ATLANTIC HIGHLANDS PLANNING BOARD
APPLICATION FOR VARIANCE

Re: Application for a Variance; Initial Submission
6 Bonnie Brae Path
Atlantic Highlands, NJ Block 17 Lot 3

Re: Application for a Variance; Second Submission
6 Bonnie Brae Path
Atlantic Highlands, NJ Block 17 Lot 3

Atlantic Highlands Borough Planning Board
 Re: Ruane & Dewis
 Use & Bulk Variance Application – Review #1

Exterior Elevations

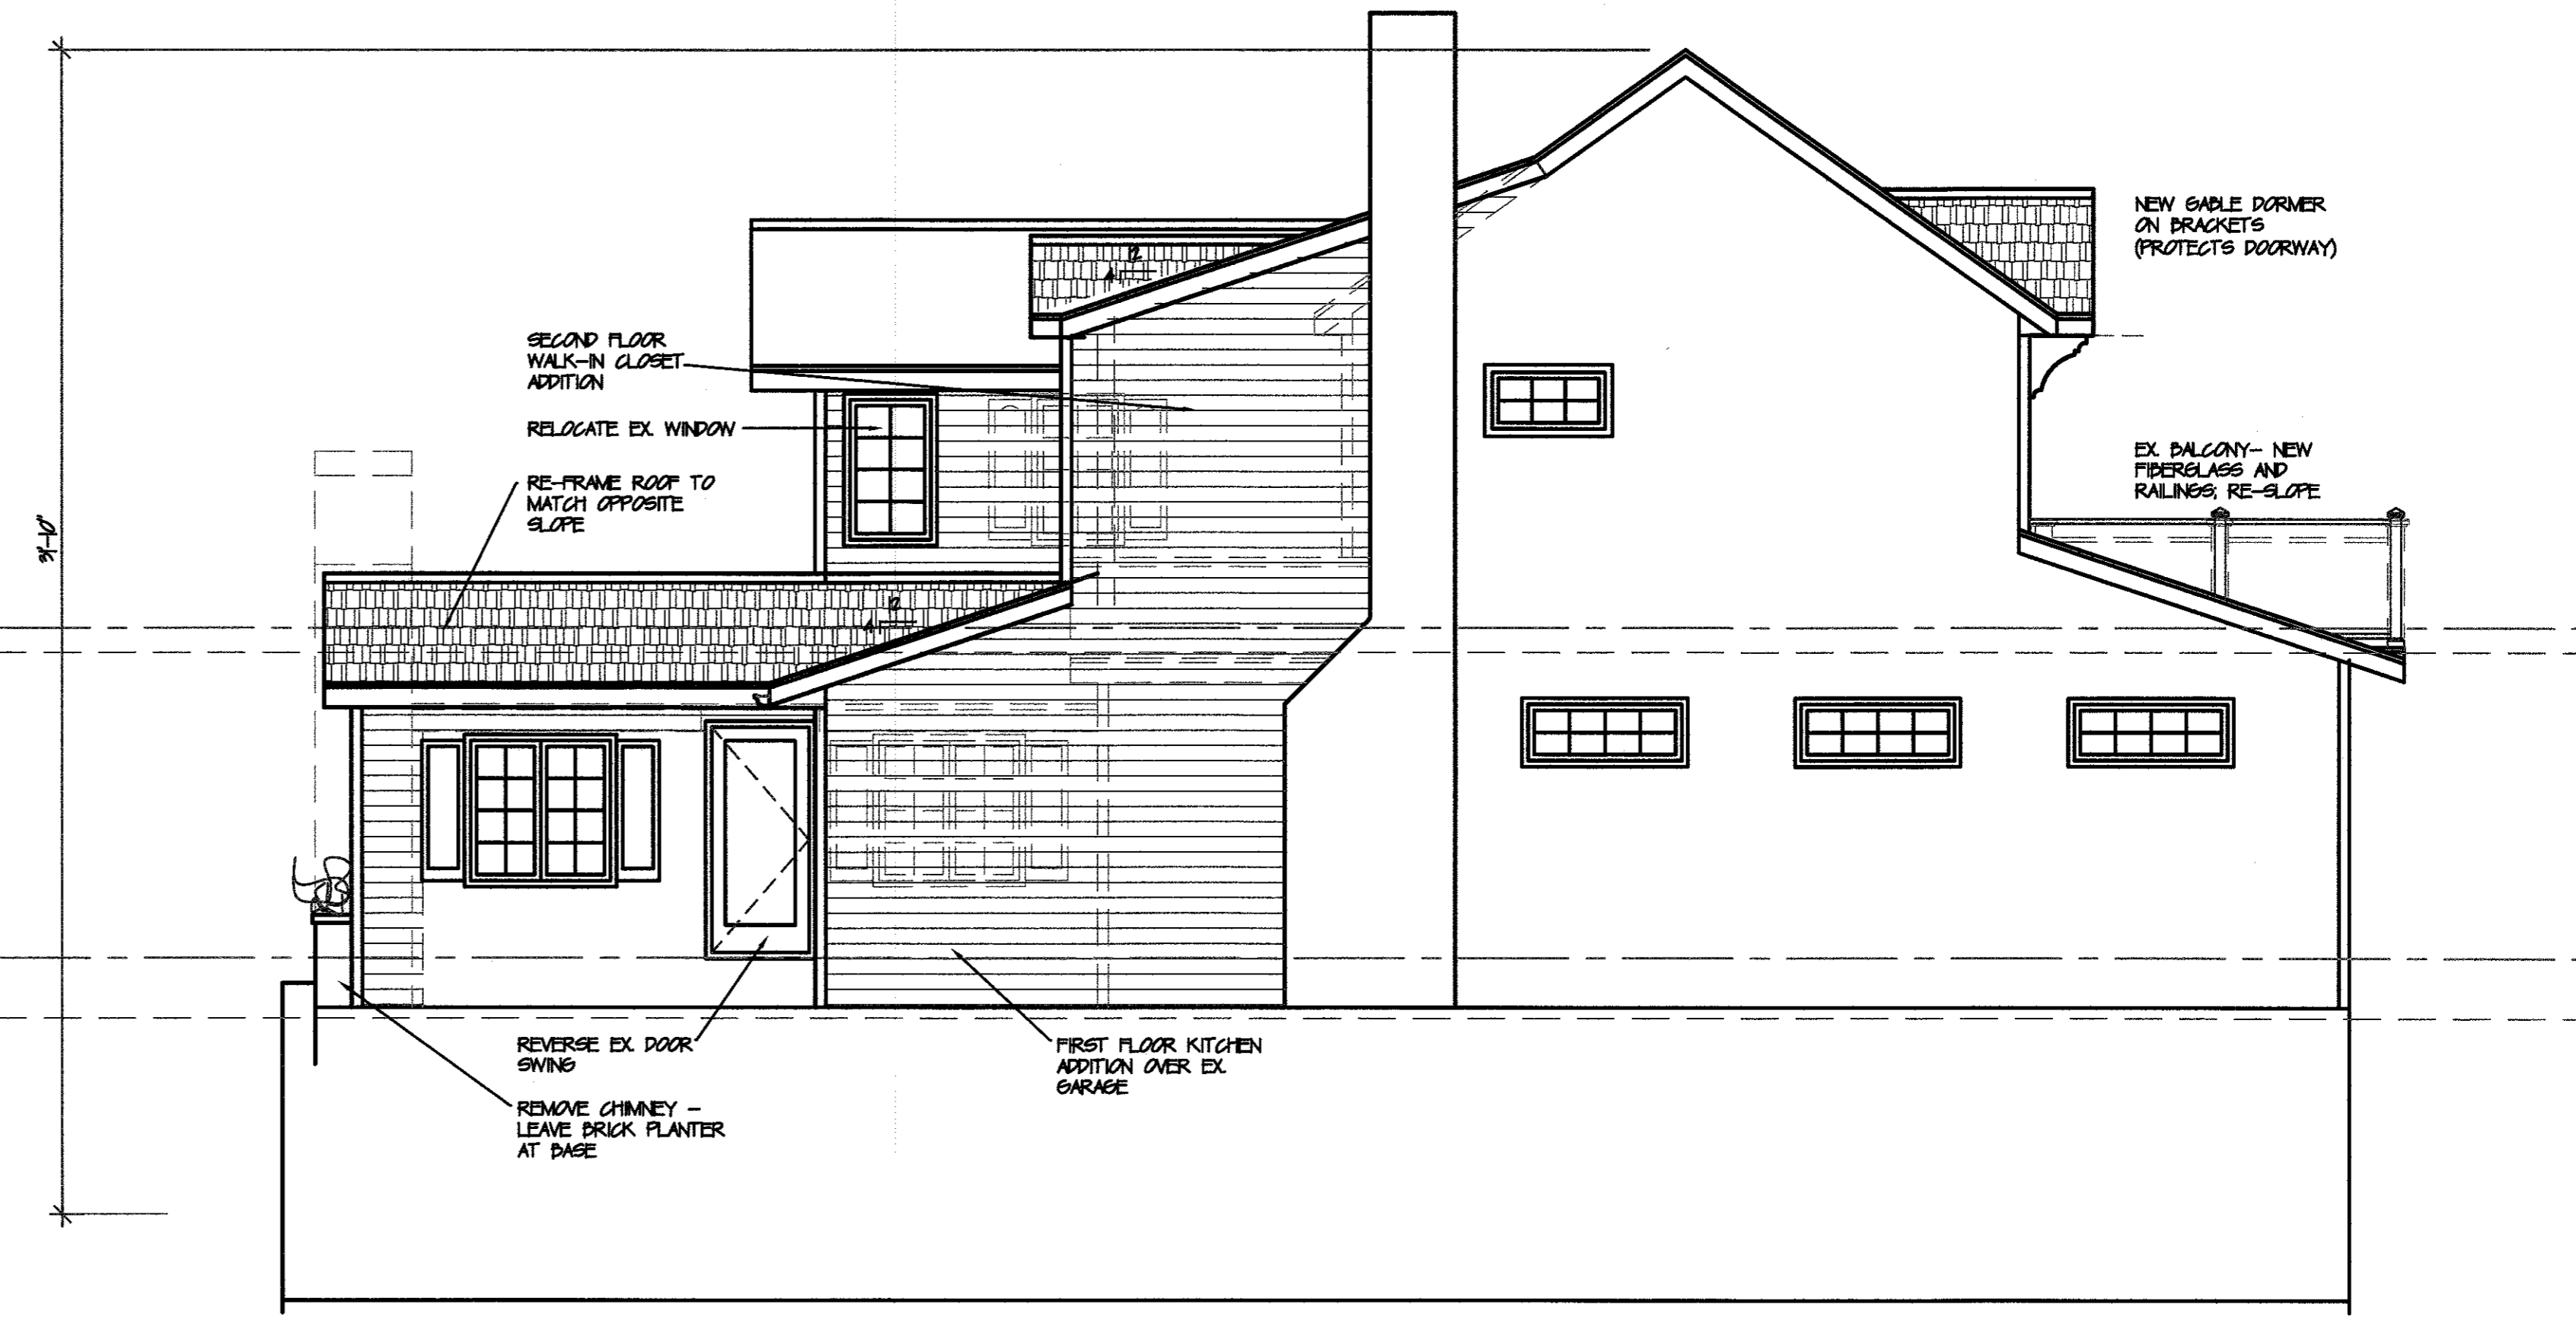
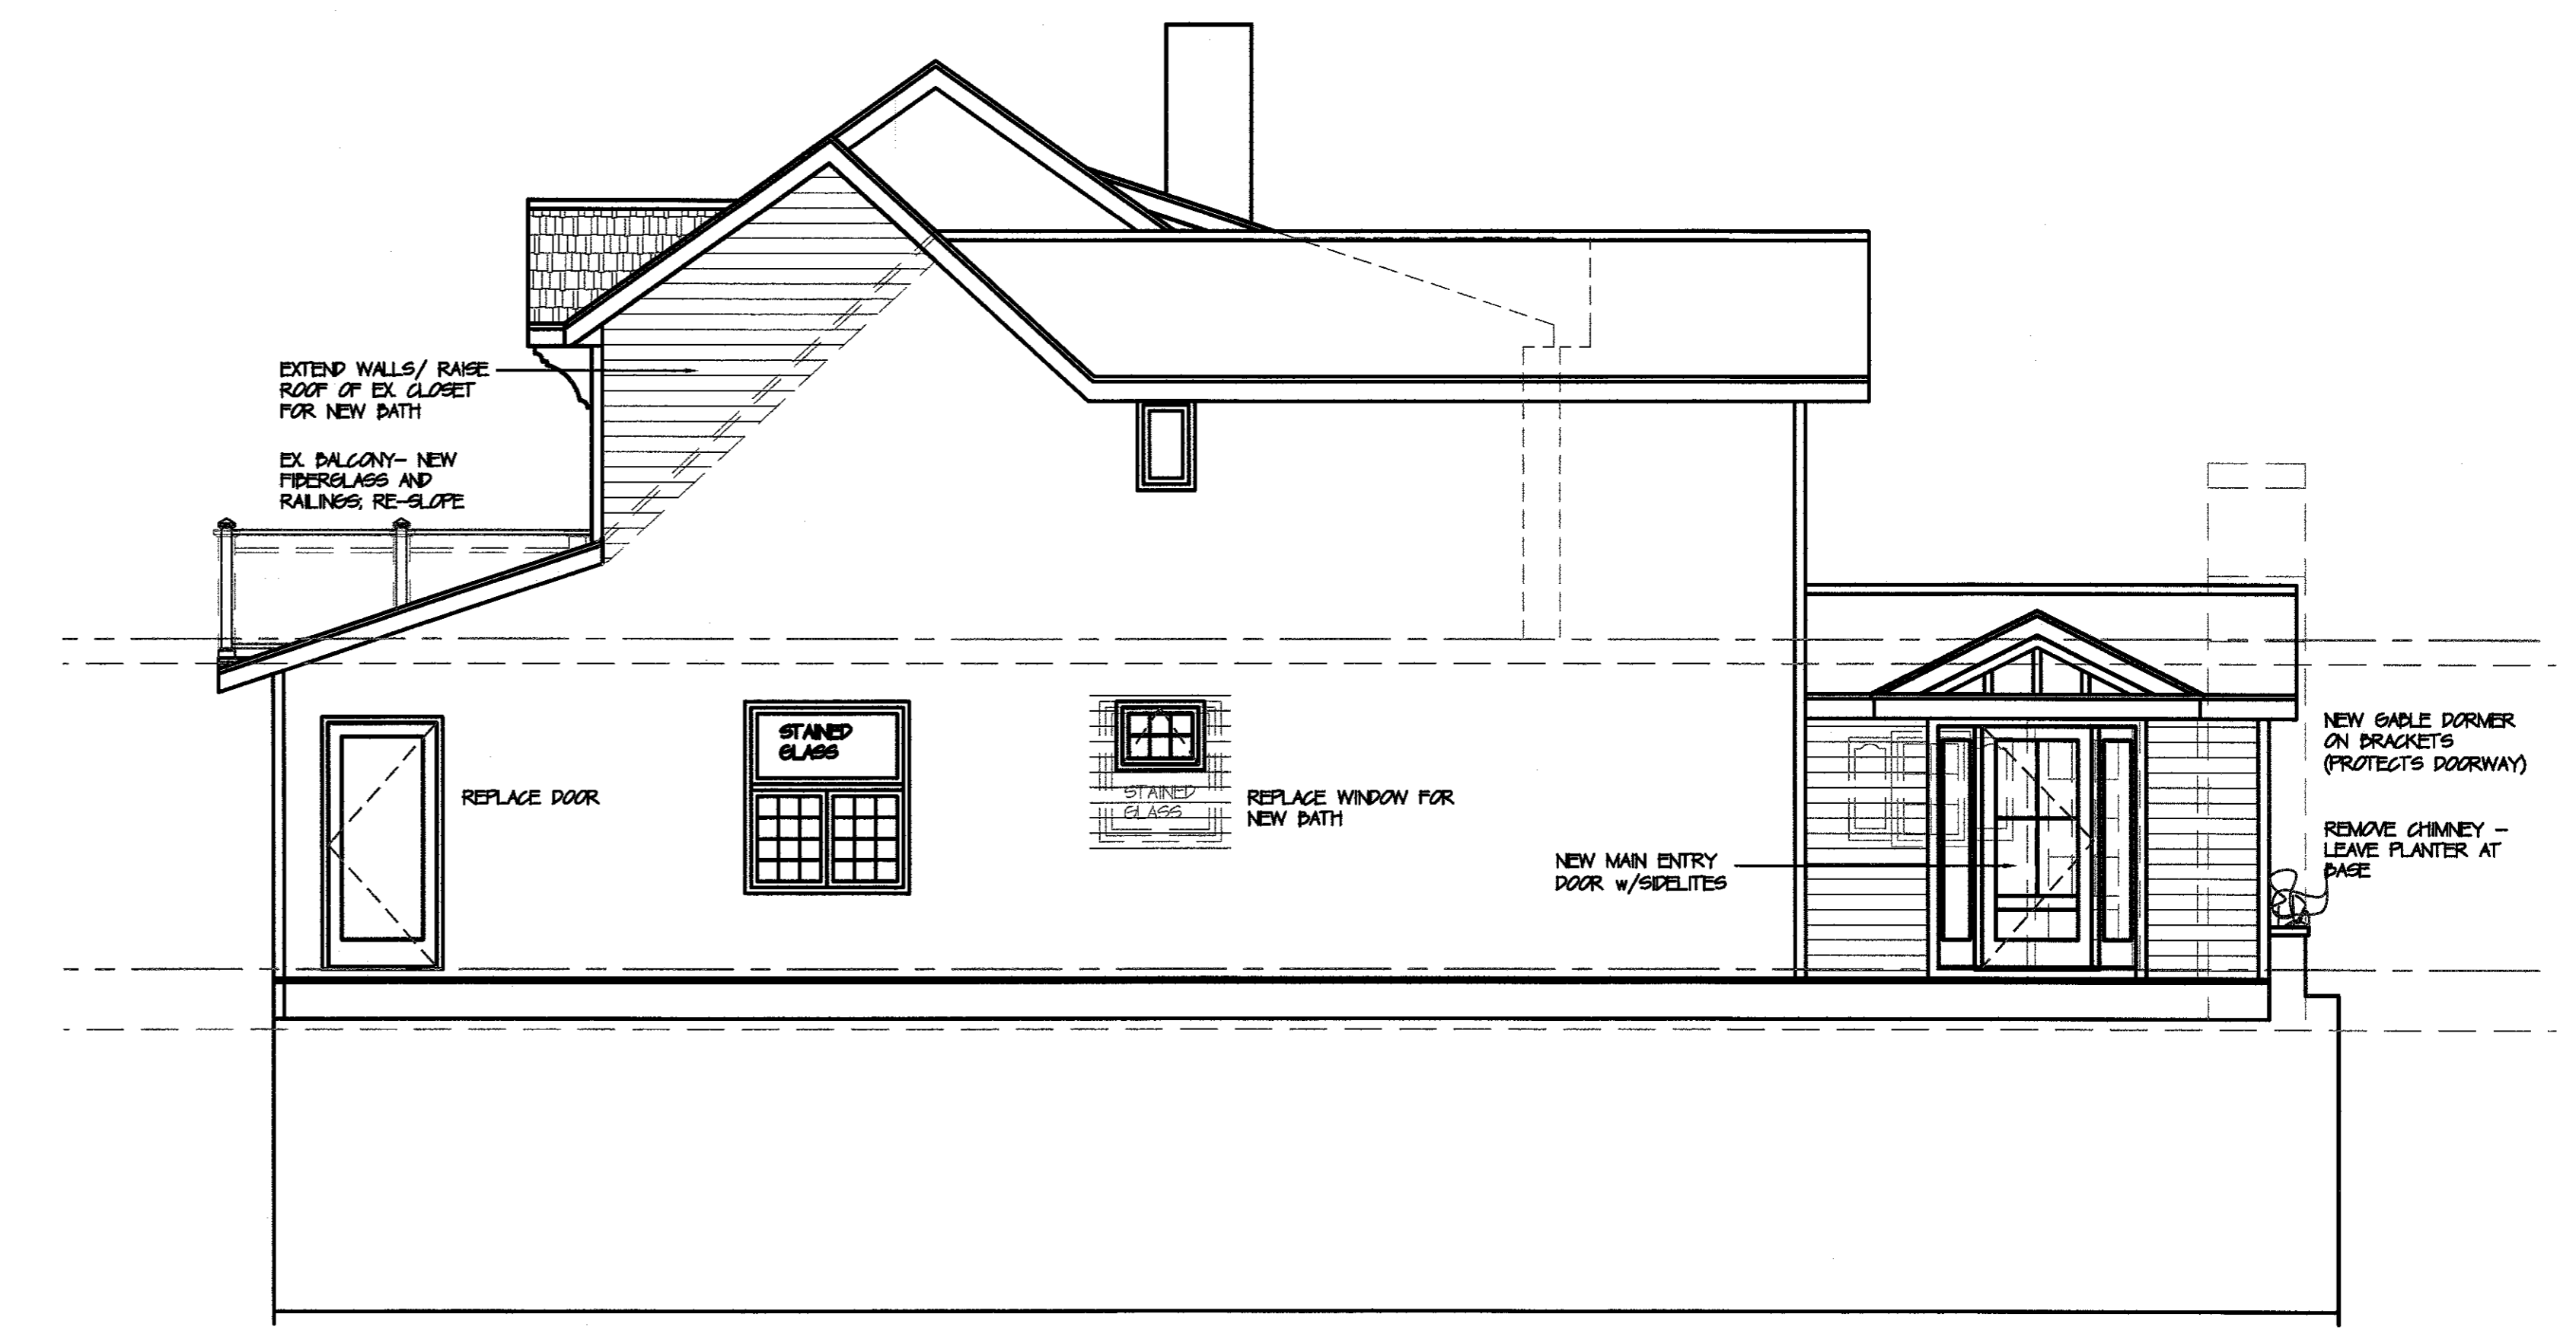
- d) The Applicant should provide testimony and/or exhibits to address the appearance of the modified dwelling and confirm that the dwelling will comply with the applicable zoning requirements for maximum height and number of stories.

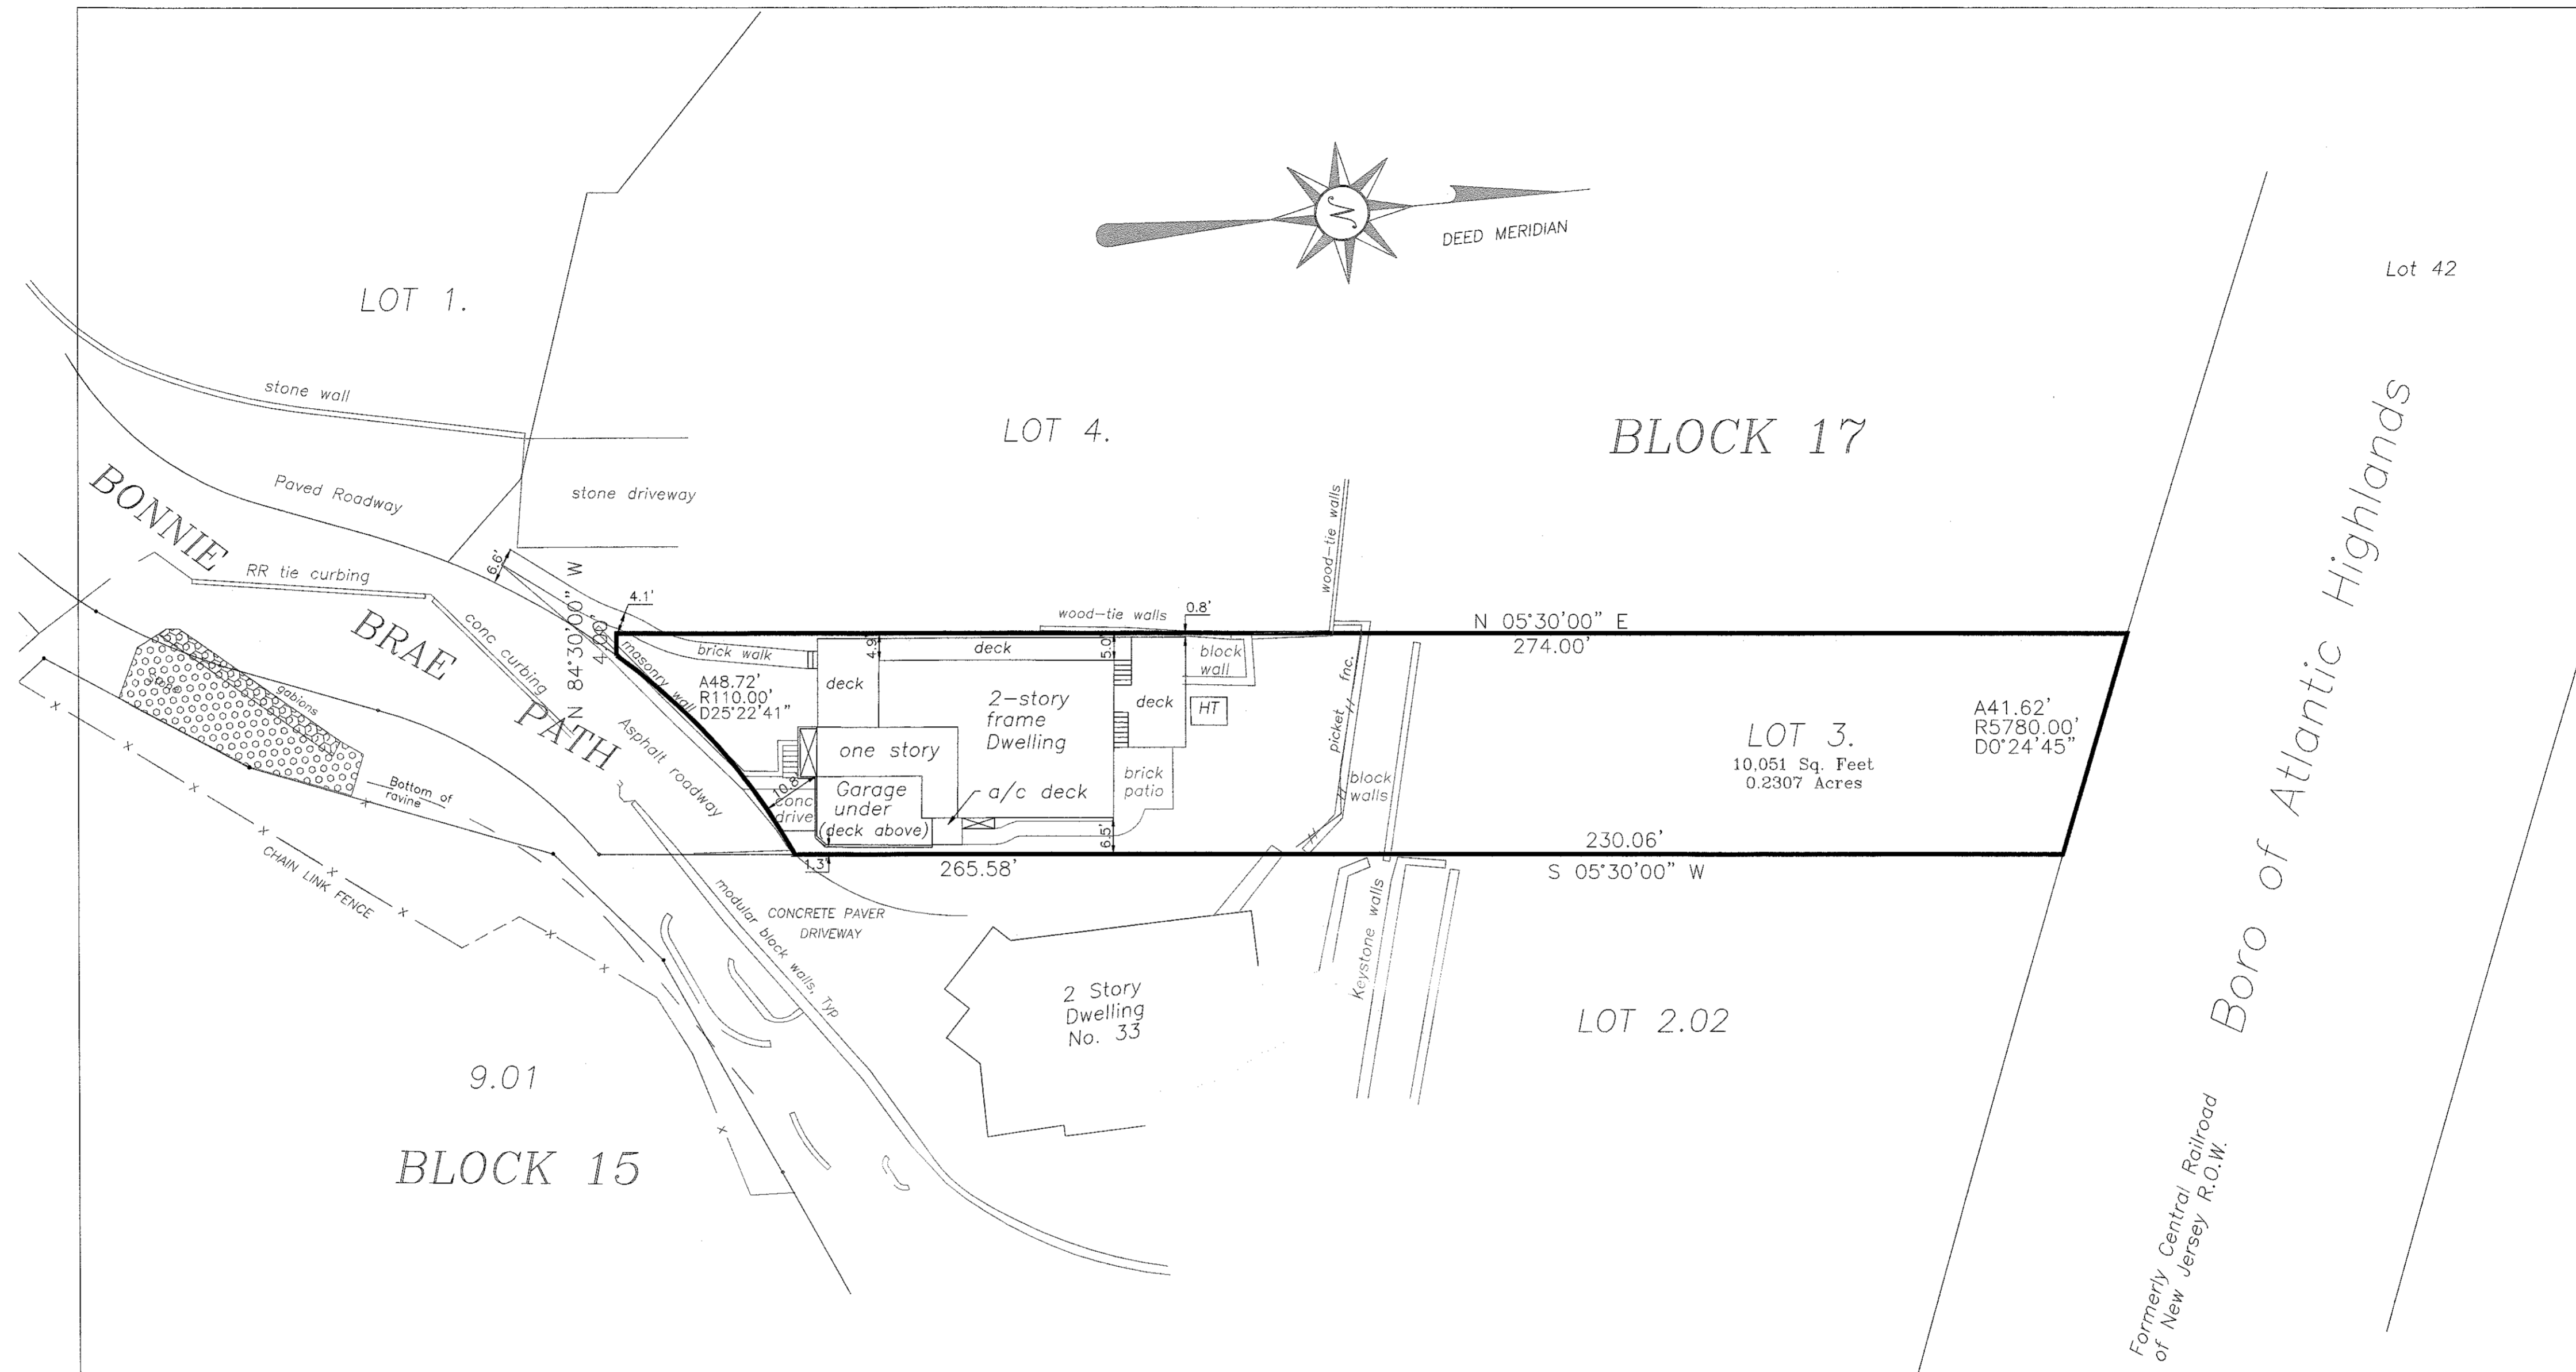
confirming same should be provided. In addition, the Applicant should clarify where the topographic information was obtained from as none is included in the survey.

7b. A sealed copy of the survey to scale is enclosed
